Aqua Lung America

TECHNICAL BULLETIN

Mar 22, 2010
No. 29

SUBJECT: Recall Notice of the Apeks WTX Inflator.

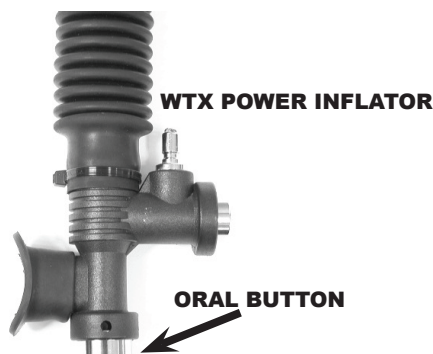
PROBLEM: Aqua Lung has been made aware of a case of a poorly retained oral inflate button that came off of an Apeks WTX inflator. If the button were to come off, the spring behind the button would also come off thereby removing the tension needed to keep the valve closed. If this were to occur in the water, it could lead to a leak of the BC contents out of the oral mouthpiece.

The button is supposed to be adhered with a high-strength thread locker. Our research into the matter indicates that some units may have been improperly adhered by our supplier. Because an inspection of the button is easy to do, Aqua Lung believes that it is prudent to inspect all units in the field. We believe that very few, if any, of the WTX inflators will exhibit this problem.

CORRECTIVE ACTION: The detailed inspection procedure as well as the corrective action has been provided to your local Aqua Lung/Apeks dealer. If you have an Apeks WTX inflator that falls into the range listed above, please return your WTX inflator to your local Aqua Lung/Apeks dealer for inspection.
